# SERVICE BULLETIN

Supplement No. 2

Service Bulletin No. 342G

**Diagram No. 30 -- IO-540-M1C5**

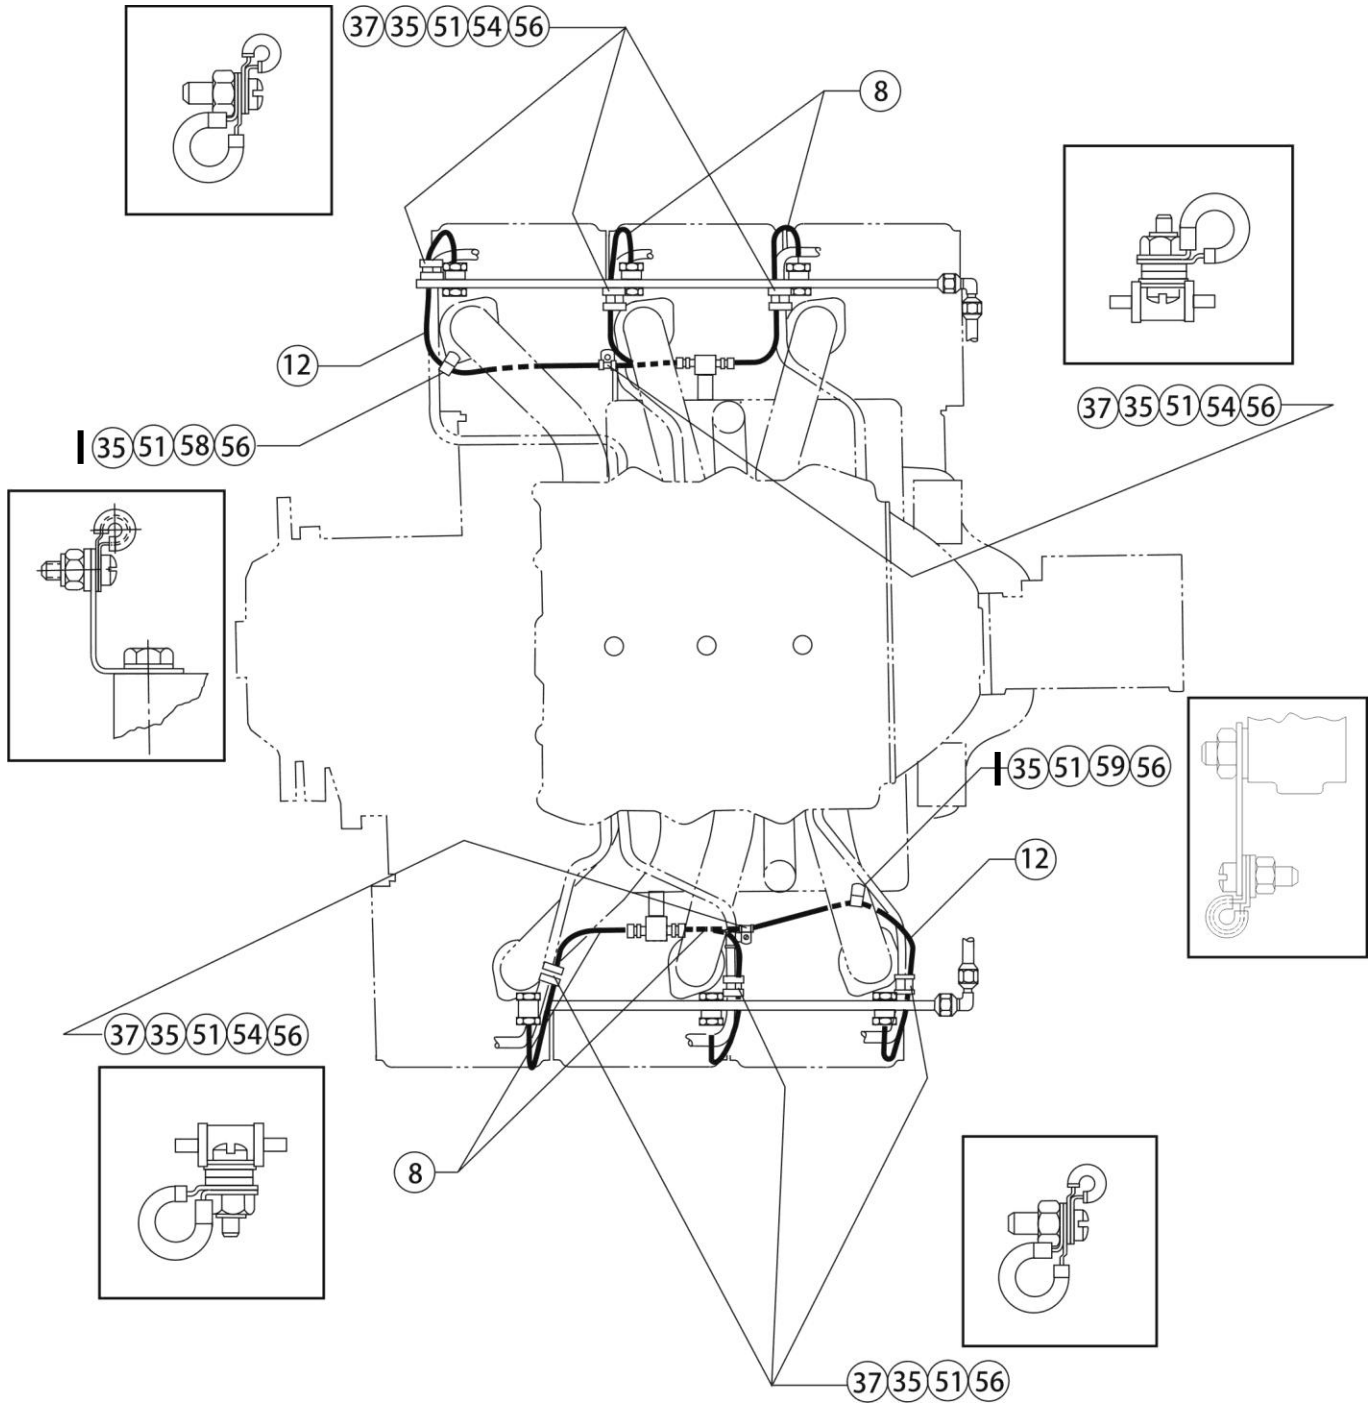
2. Corrects the call out designations for the hardware part numbers used in two locations in Diagram No. 30 on page 38 of 47.
